REGIONAL REVIEW NOTIFICATION

Name of Proposal: Gateway 75 Industrial Park

Review Type: Development of Regional Impact

Preliminary Report:	August 14, 2006	DEVELOPMENT OF REGIONAL IMPACT REVIEW REPORT	Project:	Gateway 75 Ind Park #1159
Final Report Due:	September 15, 2006		Comments Due By:	August 28, 2006

V/C Ratios

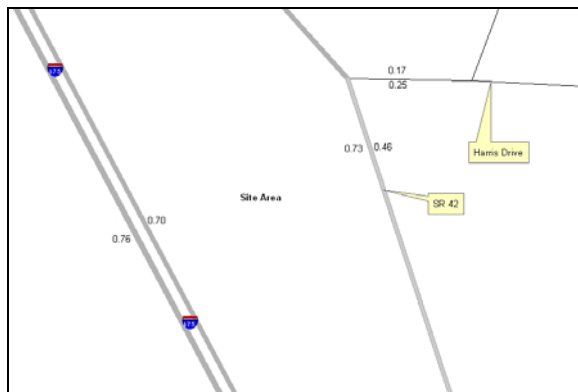
For the V/C ratio graphic, the data is based on 2005, 2010 and 2030 A.M./P.M. peak volume data generated from ARC's travel demand model for Mobility 2030, the 2030 RTP and the FY 2006-2011 TIP, approved in March of 2006. The travel demand model incorporates lane addition improvements and updates to the network as appropriate. As the life of the RTP progresses, volume and/or V/C ratio data may appear inconsistent due to (1) effect of implementation of nearby new or expanded facilities or (2) impact of socio-economic data on facility types.

D.R.I. SITE PLAN

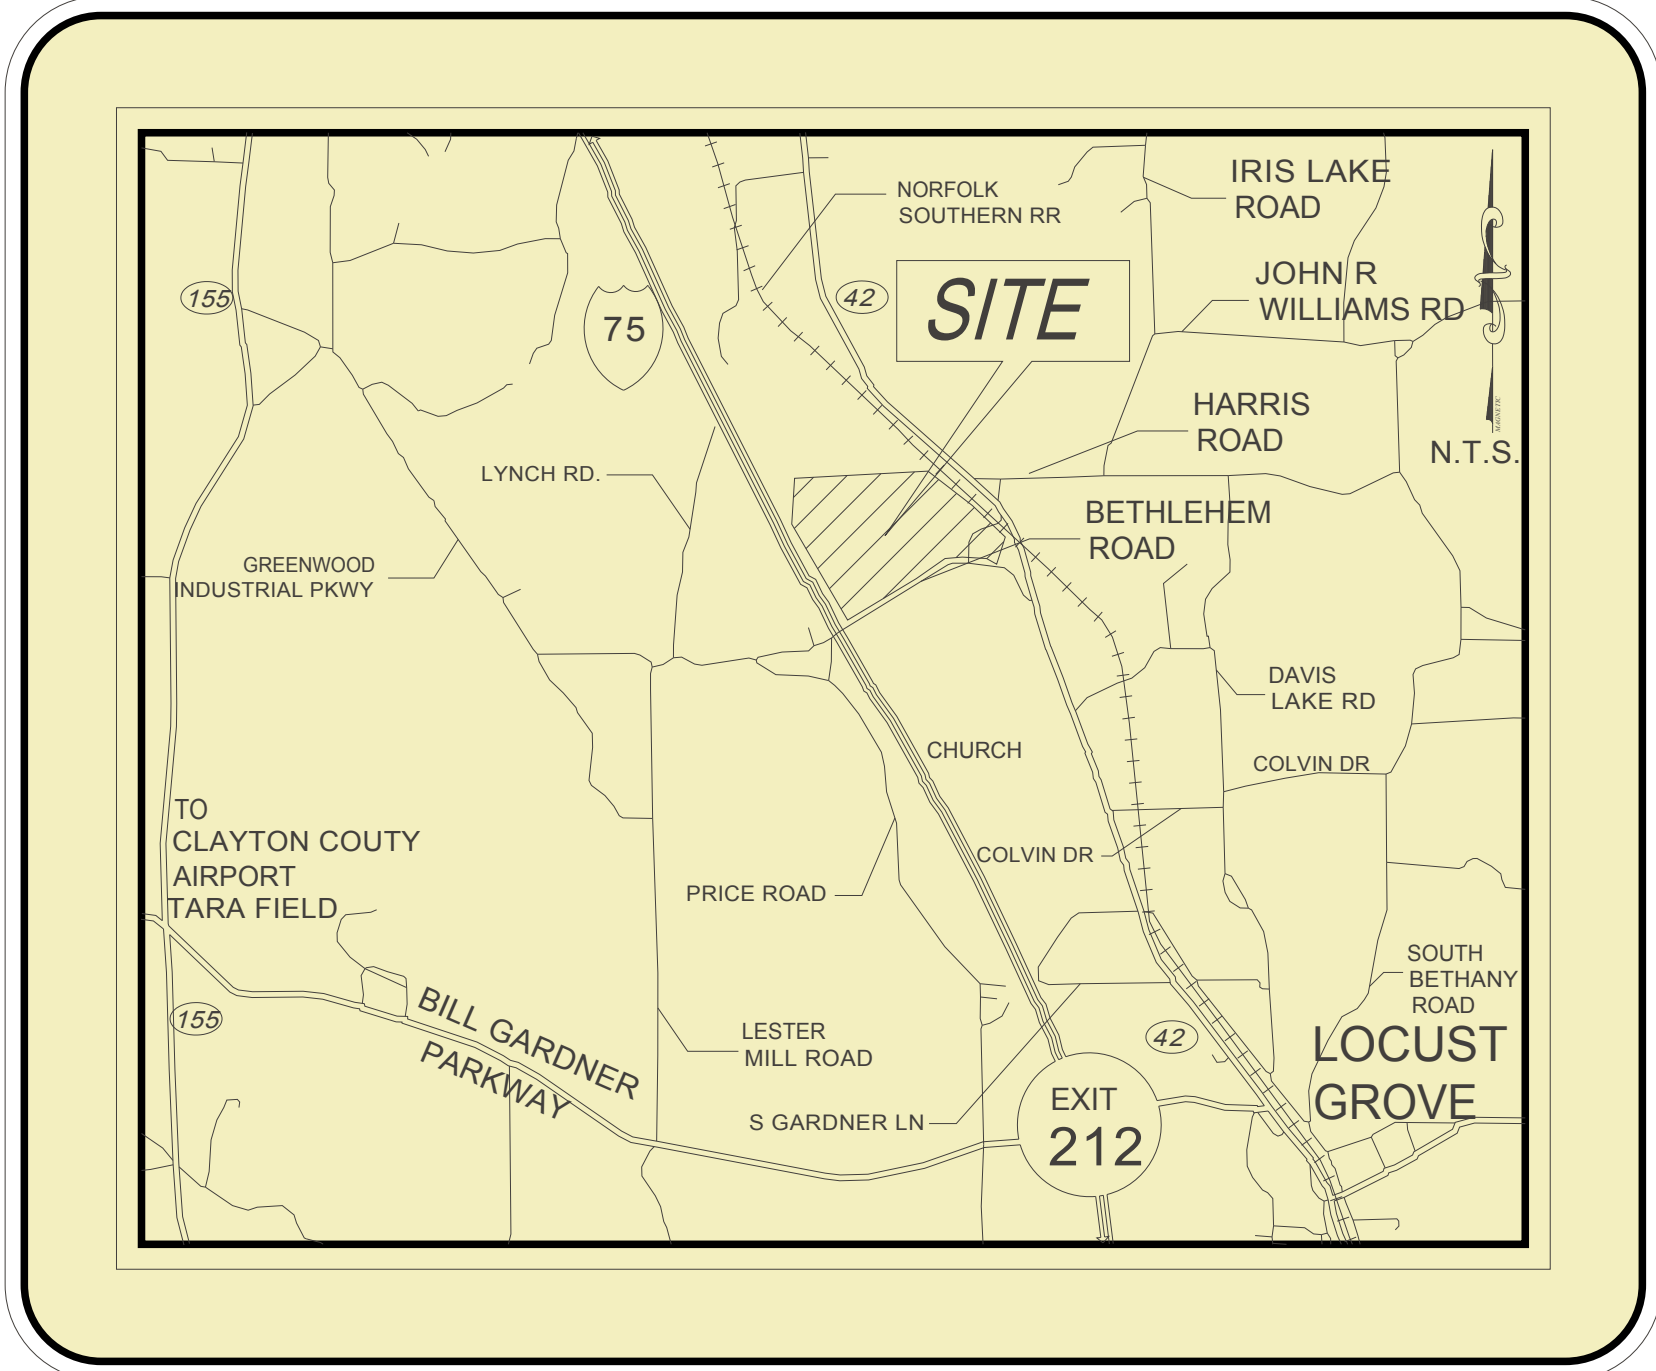
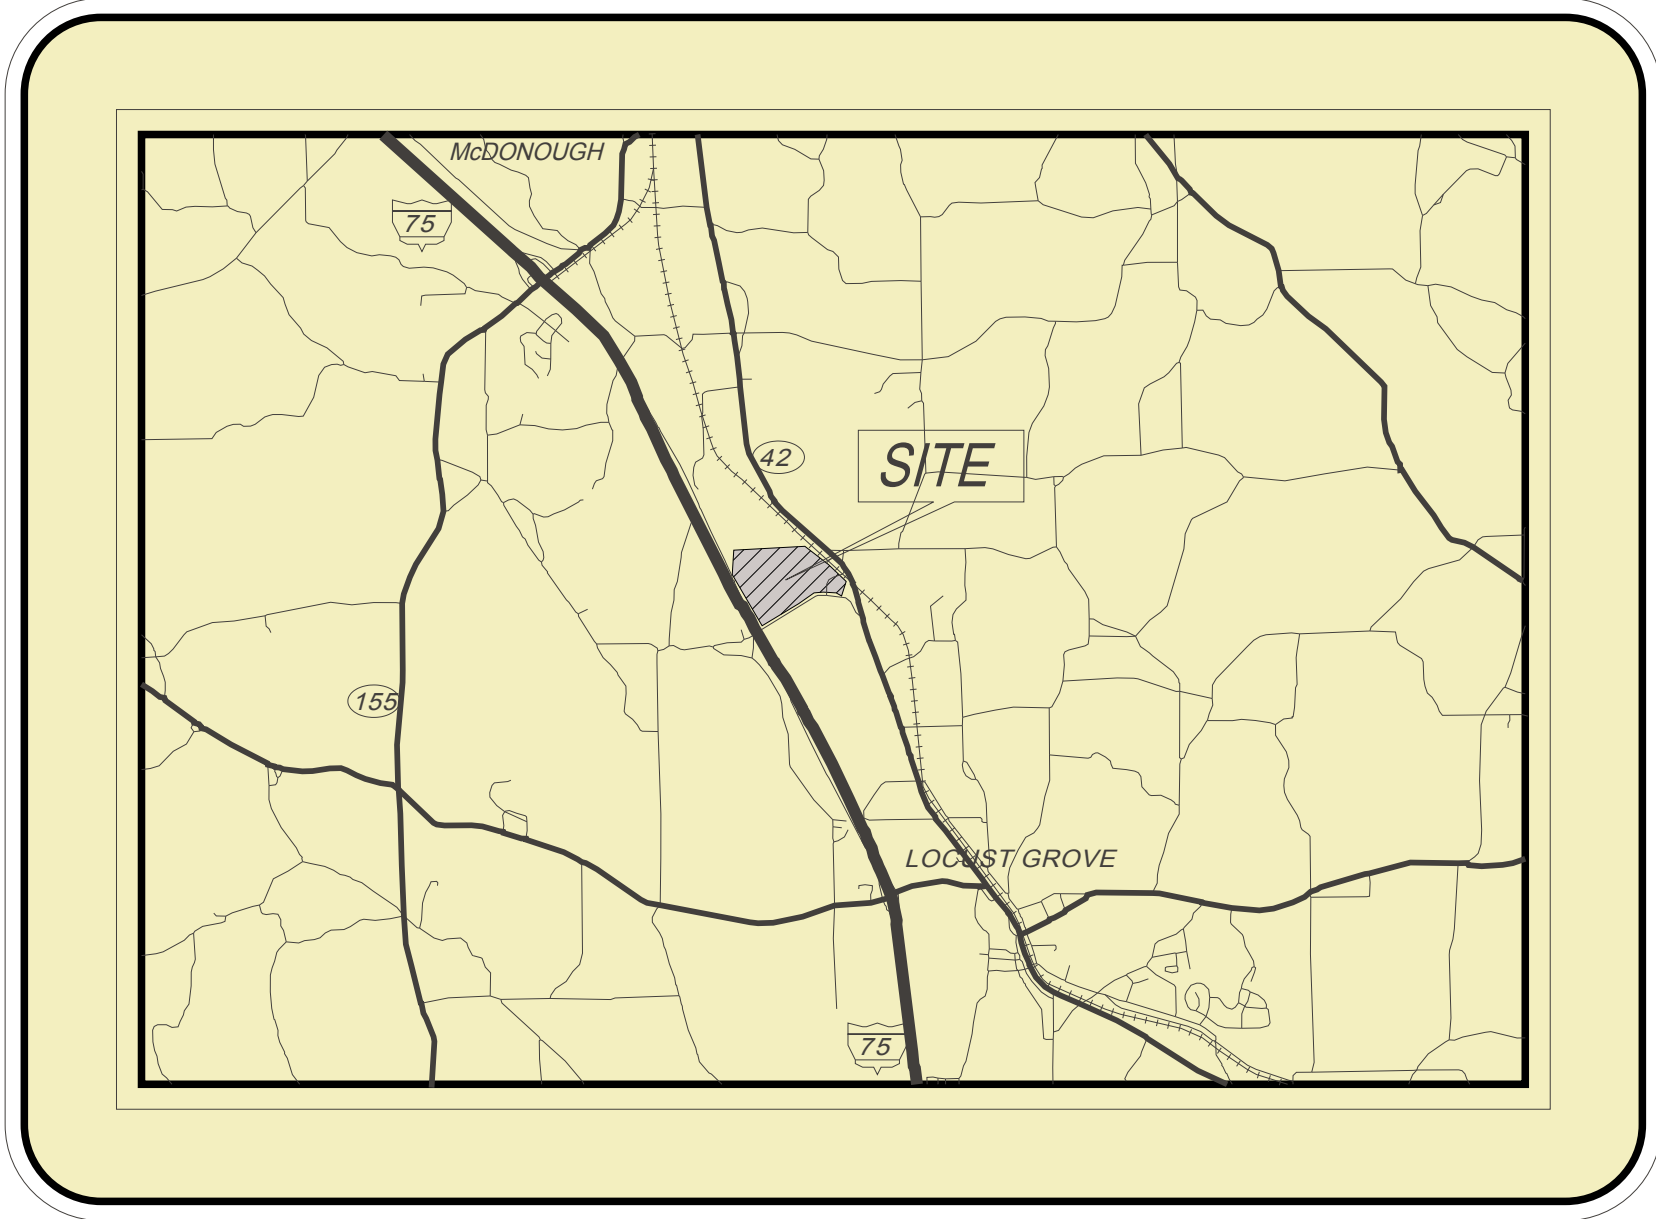
Refinement of the site plan is recommended to maintain and improve the environmental integrity of the surrounding area. Clear cutting of the vegetation should be minimized where possible. It is recommended that appropriate measures are taken to ensure the protection of the streams located on the site.

Grading of the site should be kept to a minimum where possible. Stormwater management controls are of critical importance for preserving the existing water quality of the various water entities in the immediate area. In refining the site plan, it is recommended that significant consideration be given to grading and potential runoff, and kept to a minimum where possible.
